CITY OF CODY  
PLANNING, ZONING AND ADJUSTMENT BOARD  
TUESDAY, FEBRUARY 13, 2018  
CITY HALL COUNCIL CHAMBERS @ 12:00 NOON

<b>MEETING DATE:</b>	FEBRUARY 13, 2018	<b>TYPE OF ACTION NEEDED</b>	
<b>AGENDA ITEM:</b>		P&Z BOARD APPROVAL:	X
<b>SUBJECT:</b>	SITE PLAN REVIEW: WYOMING LEGACY MEATS COLD STORAGE BUILDING SPR 2018-09	RECOMMENDATION TO COUNCIL:	
<b>PREPARED BY:</b>	TODD STOWELL, CITY PLANNER	DISCUSSION ONLY:

<b>MEETING DATE:</b>	FEBRUARY 13, 2018	<b>TYPE OF ACTION NEEDED</b>	
<b>AGENDA ITEM:</b>		P&Z BOARD APPROVAL:	X
<b>SUBJECT:</b>	SITE PLAN REVIEW: LEGEND TOWERS OFFICE EXPANSION (RADIO STATION). SPR 2018-10	RECOMMENDATION TO COUNCIL:	
<b>PREPARED BY:</b>	TODD STOWELL, CITY PLANNER	DISCUSSION ONLY:

<b>MEETING DATE:</b>	FEBRUARY 13, 2018	<b>TYPE OF ACTION NEEDED</b>	
<b>AGENDA ITEM:</b>		P&Z BOARD APPROVAL:	X
<b>SUBJECT:</b>	SITE PLAN REVIEW: SEASONAL GREENHOUSE. SPR 2018-08	RECOMMENDATION TO COUNCIL:	
<b>PREPARED BY:</b>	TODD STOWELL, CITY PLANNER	DISCUSSION ONLY:

**1**  
C1.0 **SITE PLAN**  
SCALE: 1" = 20'

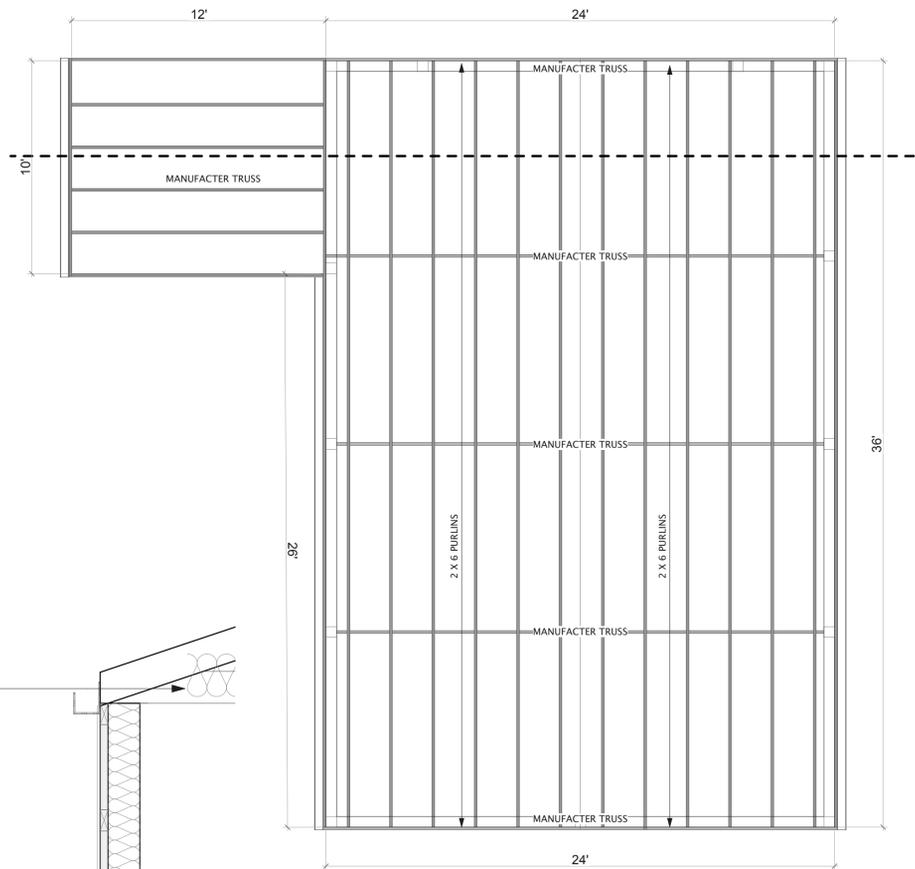
No change to the existing access to Road 2AB is proposed. A driveway to the building will be provided. The maneuvering of trucks will be able to occur fully within the property, so as to not disrupt traffic on Road 2AB. With recent snow melt, it is evident that additional gravel is needed at the road approach to Road 2AB and the vehicle maneuvering area east of the building, so as to avoid significant mud trackout onto Road 2AB.

A properly sized and designed swale is proposed to meet City storm water requirements. Storm water from the building will be collected through a gutter system and piped to the swale.

- 1) Surface the vehicle maneuvering areas with crushed road base, or similar, so as to minimize mud track out onto Road 2AB.
- 2) Encourage employees to park within the property boundaries, as opposed to the shoulder of Road 2AB, and expand the gravel parking area as needed to accommodate the parking demand.
- 3) The project must otherwise comply with the site plan and applicable building, fire, and electrical codes.
- 4) A building permit must be obtained within three years or this authorization will expire.

1 NORTH ELEVATION  
SCALE: 1/4" = 1'-0"

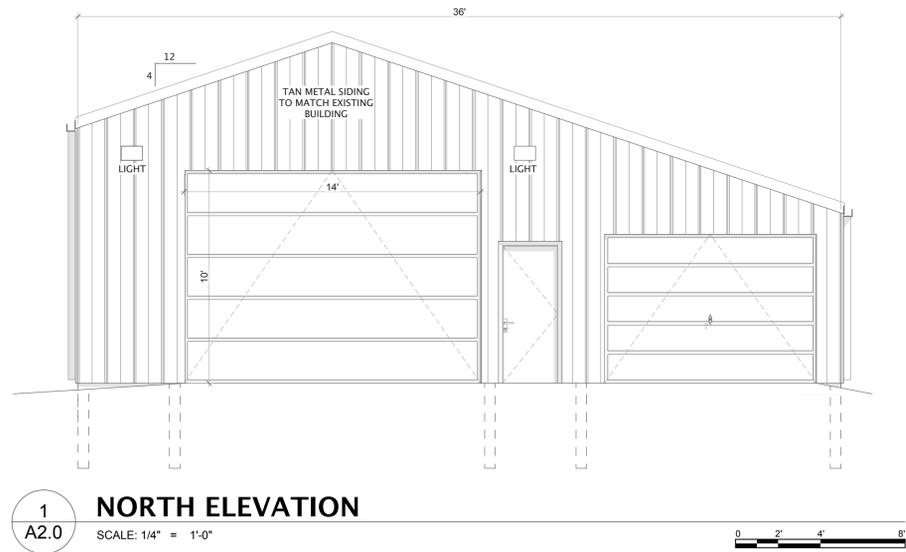
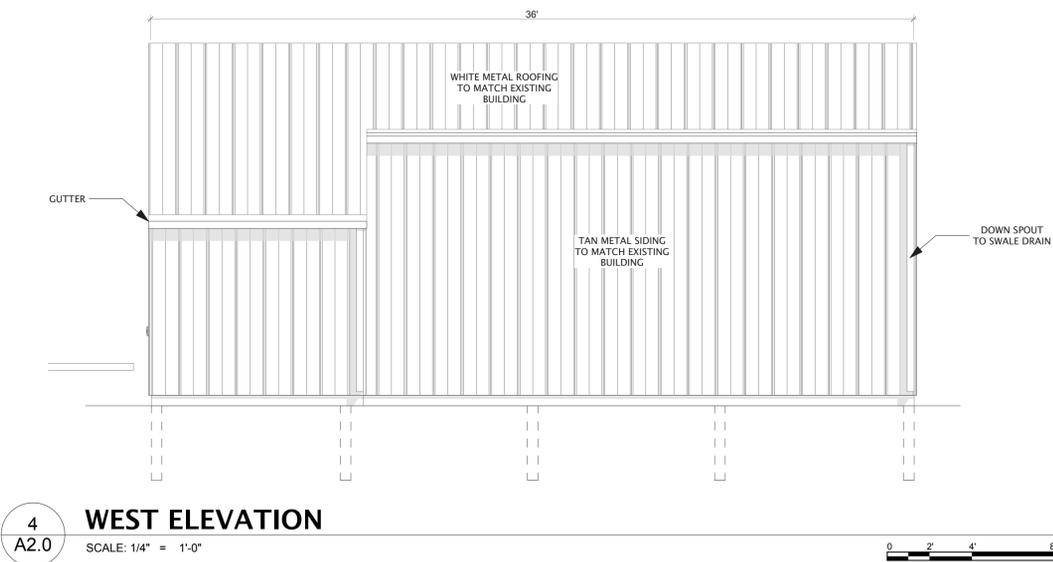
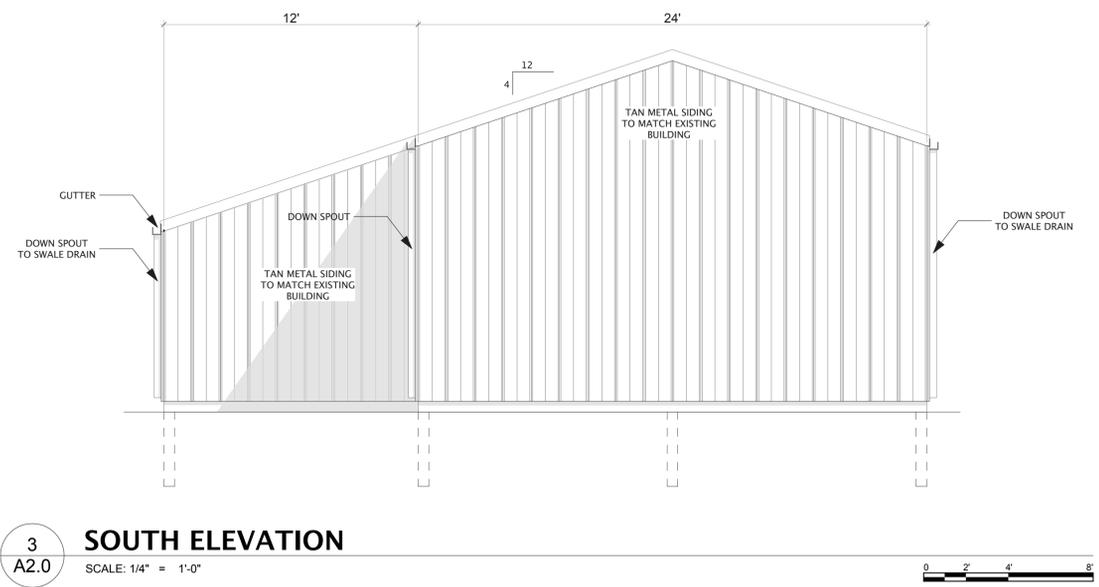
Exterior lighting is limited to two 26-watt (3,475 lumen) LED, full cut-off style fixtures, located on the north side of the building. The amount, style, and location of the lighting appears suitable.

▶ **Philips Day-brite Fsm400pmt-psc-lp-isf Fsm-series Medium Floodlight 120 208 240 277 Volt 400 Watt 1-lamp Dark Bronze Polyester Powder-coated USA Specification**

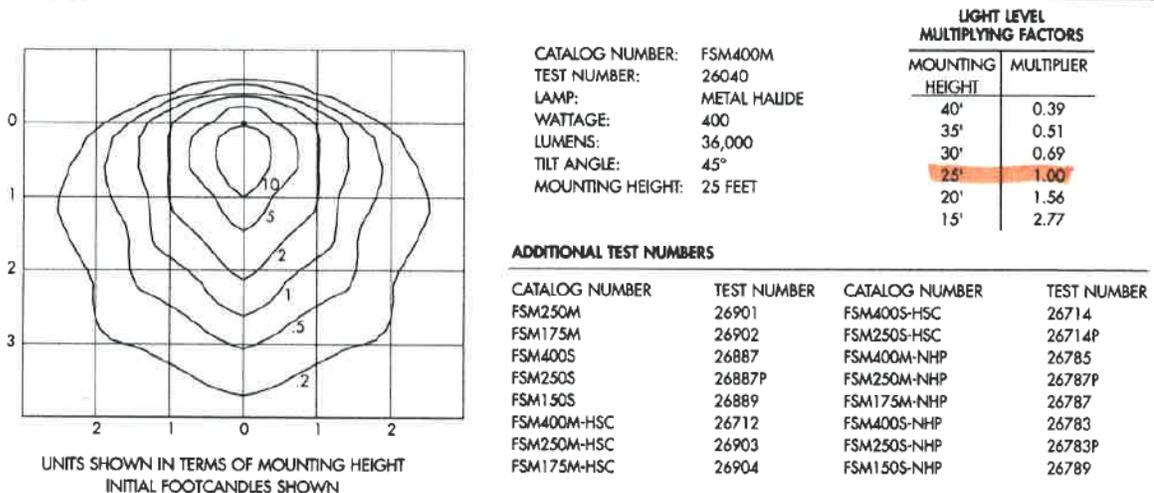
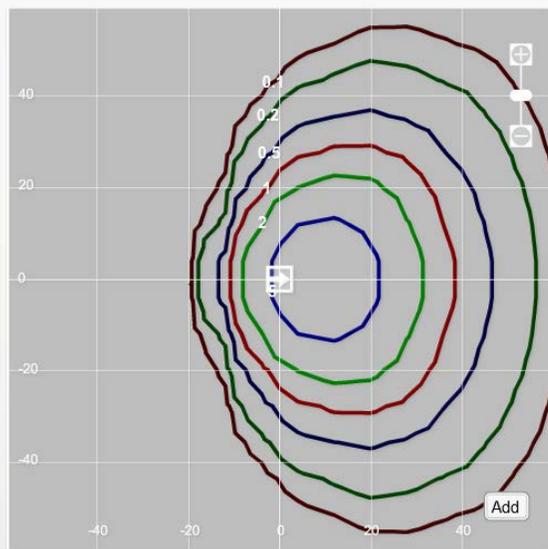
The north row of parking would be lit by a fixture on a new light pole. Mounting height is identified as 25 feet. The proposed light fixture selected for the light pole concerns staff as it is a tiltable fixture designed to be mounted at a 45-degree angle.

The proposed 400-watt metal halide floodlight would be directed towards and create glare impacts for those seeing it from Mountain View Drive, the Absaroka Bay RV park, and the nearby apartment complex. If flatter than 45 degrees, it would start to create backlighting on the residential property to the north. While not a huge deal, there is a better way, with likely less initial cost and definitely less ongoing electric costs.

1. Use a full cut-off fixture for the north parking lot light pole, with an intensity and coverage similar to the staff recommended example.
2. An encroachment permit is required for all work within the public right of way (e.g. new approach to 21<sup>st</sup> Street). The contractor is responsible for obtaining the permit.
3. Either remove the "Kidz" freestanding sign and pole, or submit a sign permit application to utilize it.
4. The project must otherwise comply with the site plan and applicable building, fire, and electrical codes.
5. A building permit must be obtained within 3 years or this authorization will expire.

**SITE PLAN**  
1" = 10'-0"

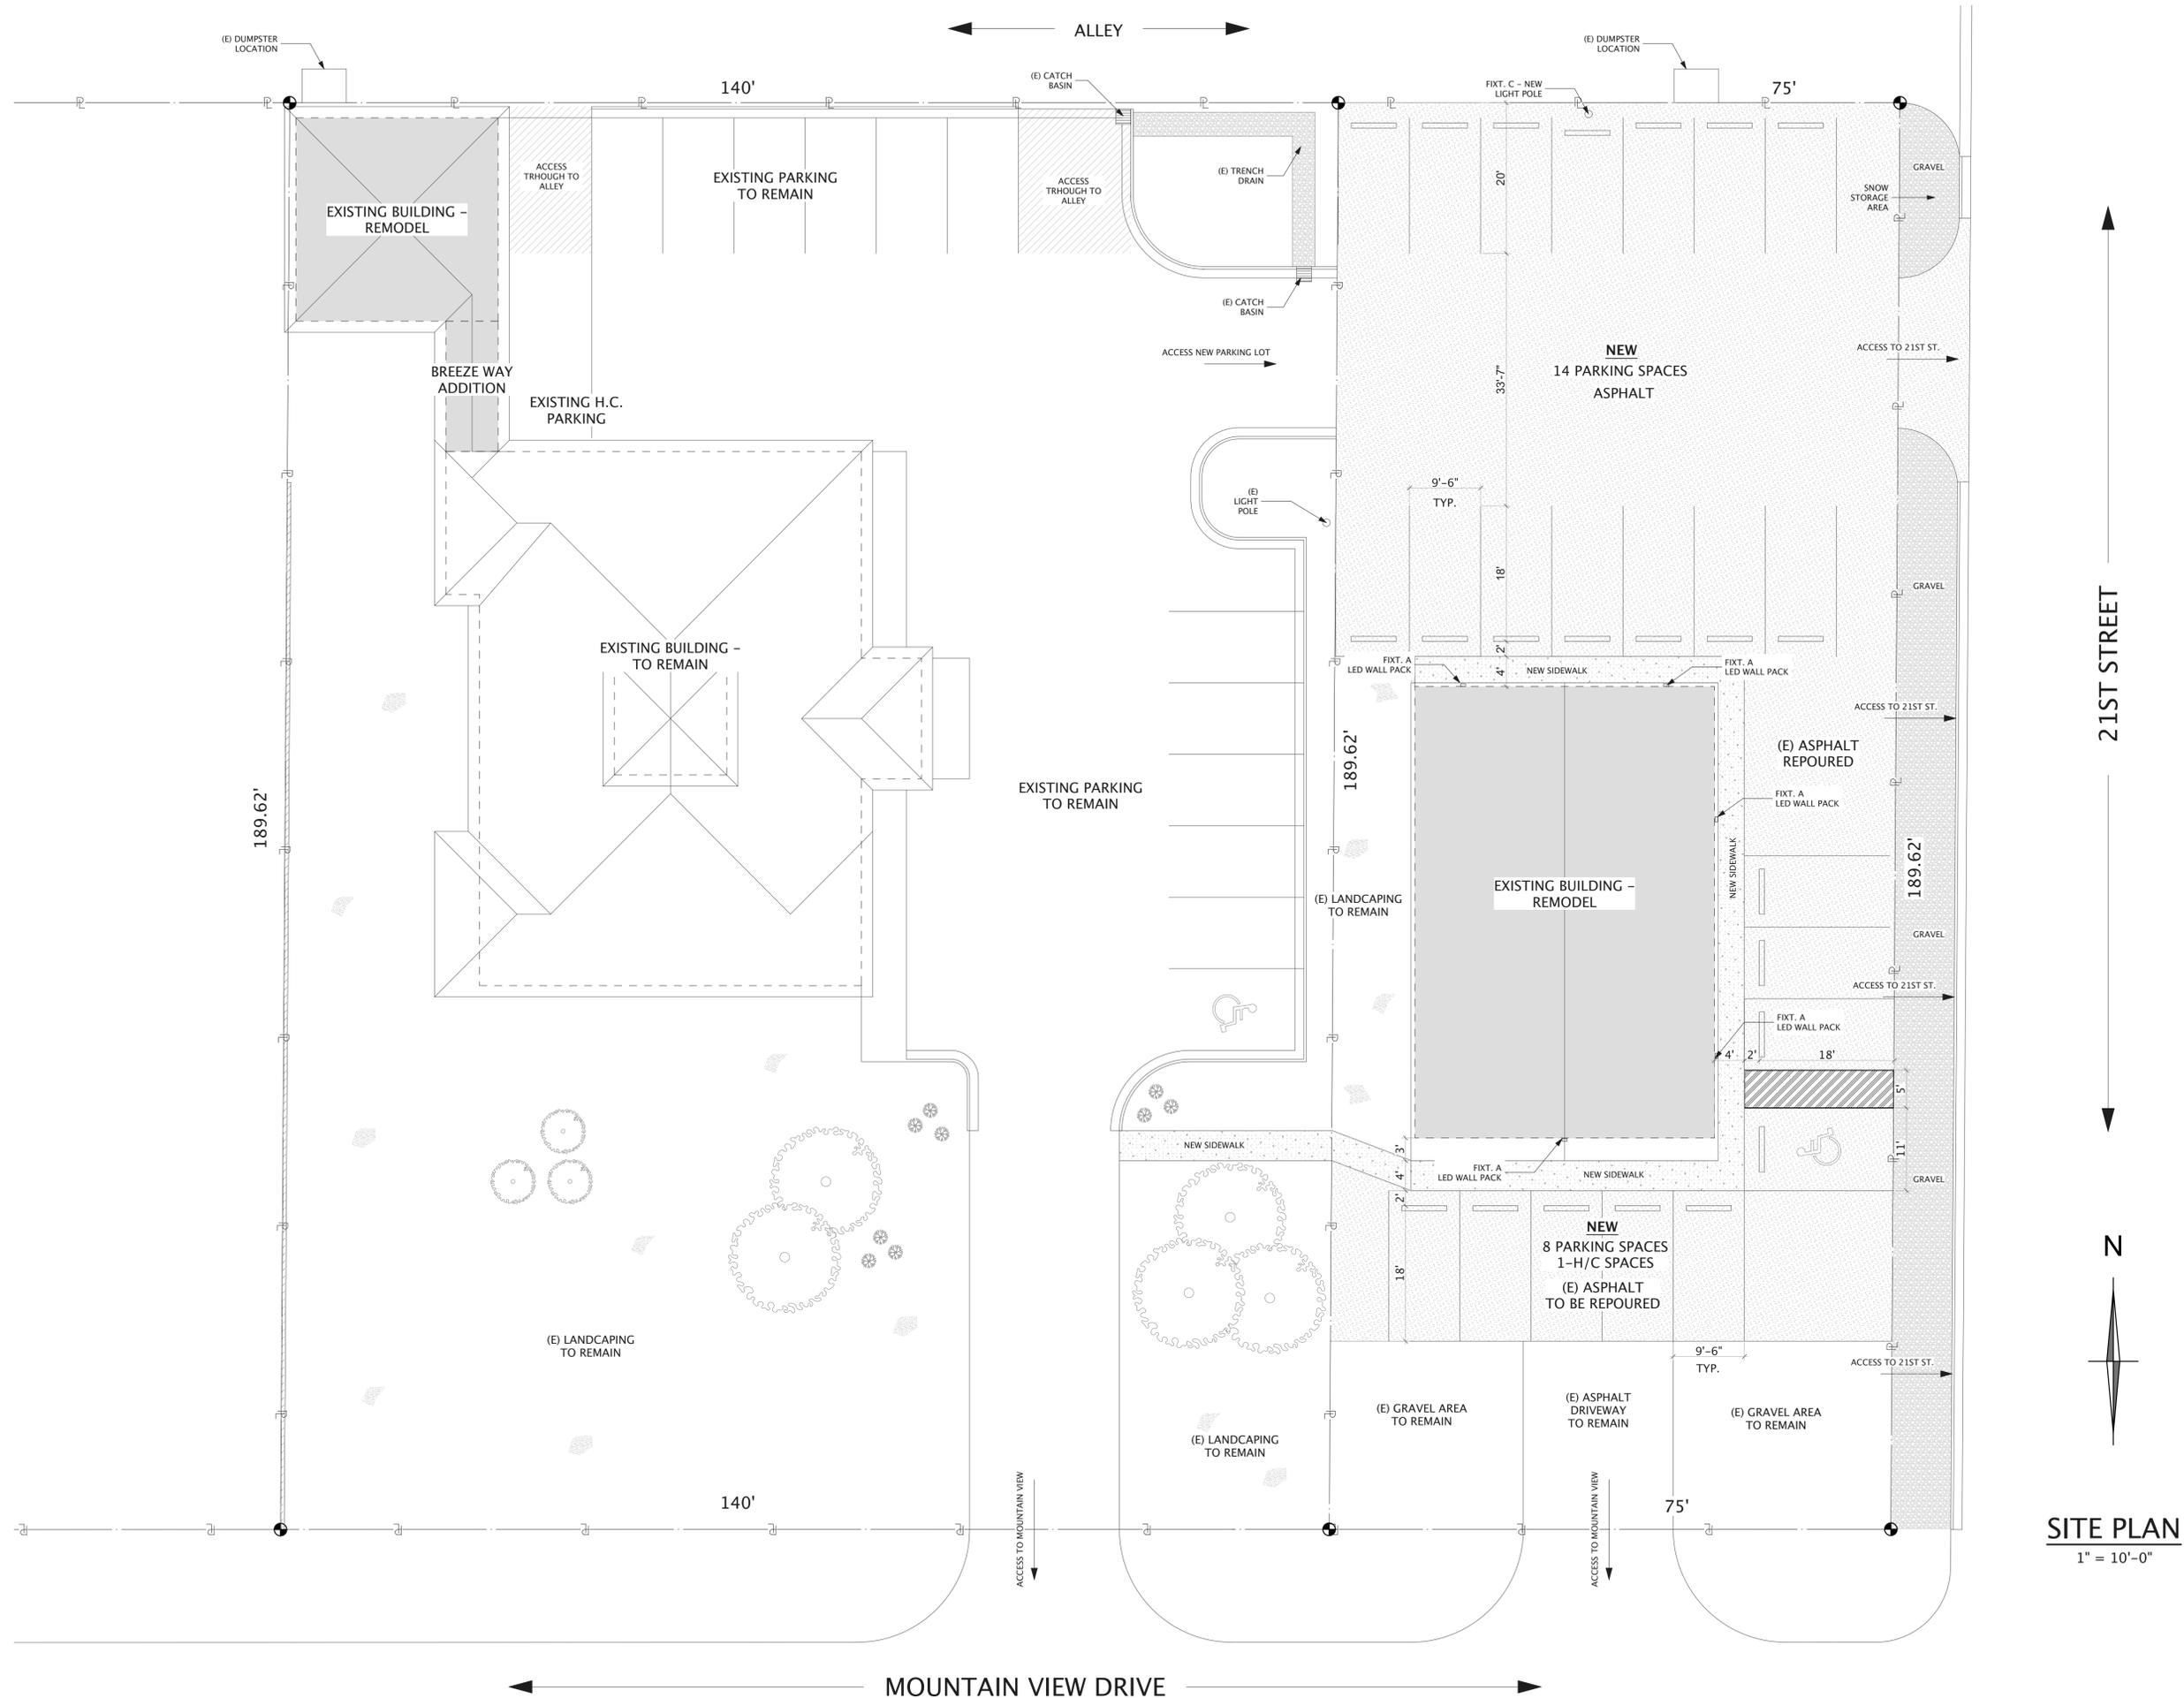
Access off of Mountain View Drive and off of 21<sup>st</sup> Street near the building is existing. The asphalt in that area will be replaced, as the existing asphalt has severely deteriorated. A new sidewalk will also be provided between the building and parking areas. A new parking area, providing fourteen new spaces, will be provided north of the building. The new parking area will be interconnected with the existing radio station parking lot and 21<sup>st</sup> Street. A new curb cut is proposed for the parking lot off 21<sup>st</sup> Street. The new parking lot meets applicable size and layout requirements.

The site plan does not include elevation data. Please note that the ADA handicap space and unloading aisle cannot be sloped more than 2% in any direction, and any ramp would have slope limitations and well (varies by length).

A total of 38 parking spaces would be provided (13 on radio station lot and 25 on former daycare lot, including the two in the garage). Based on total square footage of the buildings, and the standard ratio of one space per 250 square feet of office area, a total of 27 parking spaces are required.

It is noted that the parking situation is non-conforming in that the radio station lot requires more parking that it currently has, and will be losing two spaces to make the connection to the new parking lot. The former daycare lot has excess parking. While it is noted that the two lots will currently be under the same ownership and utilize all parking in a shared manner, if the ownership is ever split, it would be in the interest of the owner of the radio station lot (west lot) to establish a formal shared parking agreement because if the right to use the parking on the lot to the east is lost to that property, they would need to install additional parking on the radio station lot.

2 WEST ELEVATION  
A2.0 SCALE: 1/4" = 1'-0"

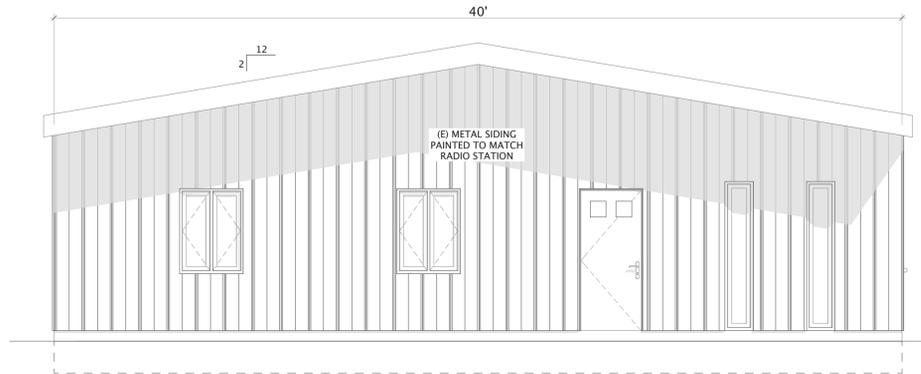
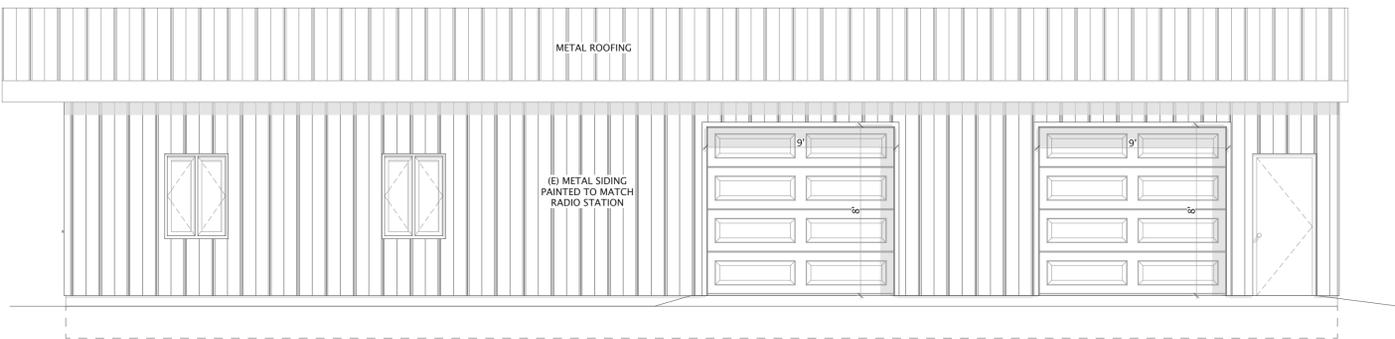
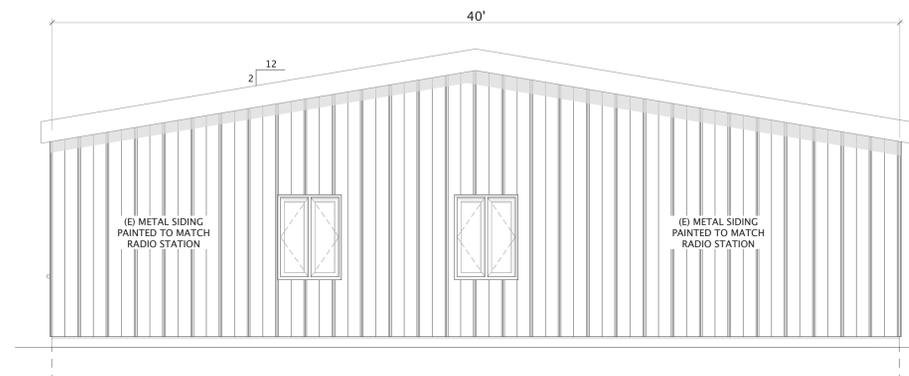
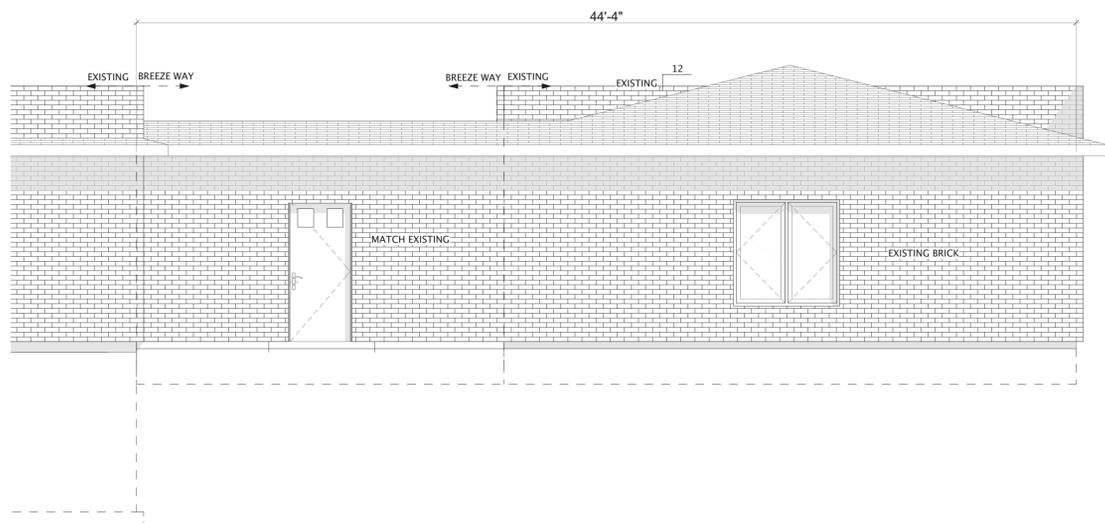
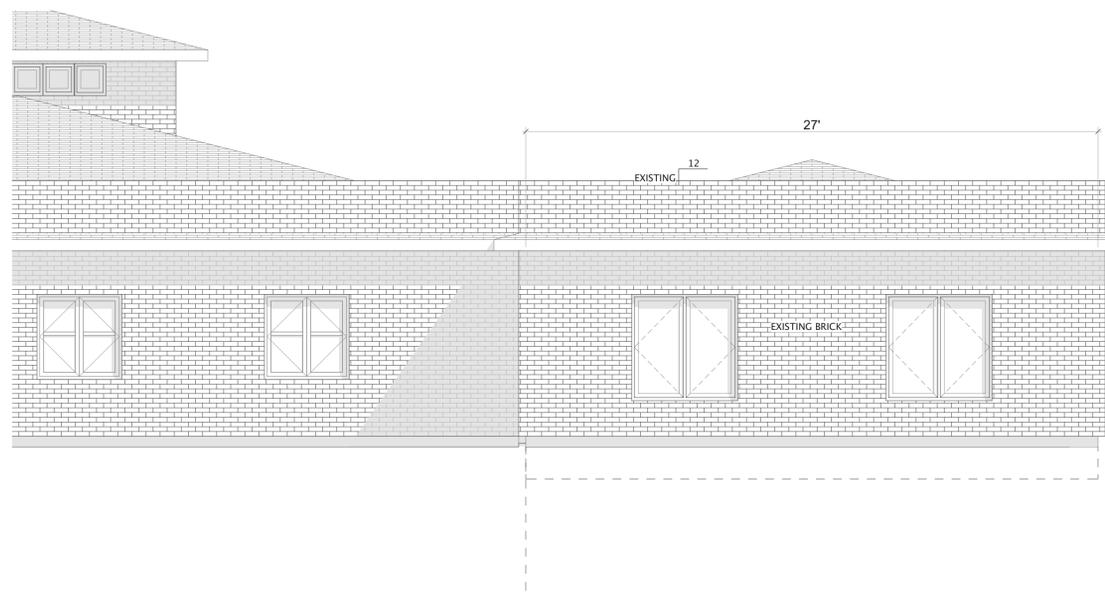
The remodel of the existing garage in the northwest corner of the property includes removal of the two overhead garage doors and installation of two 5' by 5' windows. The new breezeway is fully enclosed with two exterior doors. The brickwork on the breezeway and north side of the converted garage will match the existing brick. The roof pitch and materials (black asphalt shingles) will match the existing roof. The proposed work in this area is fully architecturally coordinated.

Conversion of the former daycare building into office area and a two-car garage includes very little work to the building exterior—primarily cutting in two 9' wide by 8' tall overhead garage doors and repainting the metal exterior of the building "to match radio station". Staff is unsure if that means a red/brown brick color, dark gray (to match walls of the cupola roof feature), or a similar complimentary color. Conceptually, any of those could work well. The existing building appearance would greatly benefit from a new paint job. It appears that the existing rock work on the building will be preserved—the Board may want to confirm.

The Board will need to determine if the architectural modifications are acceptable. Staff has no concerns.
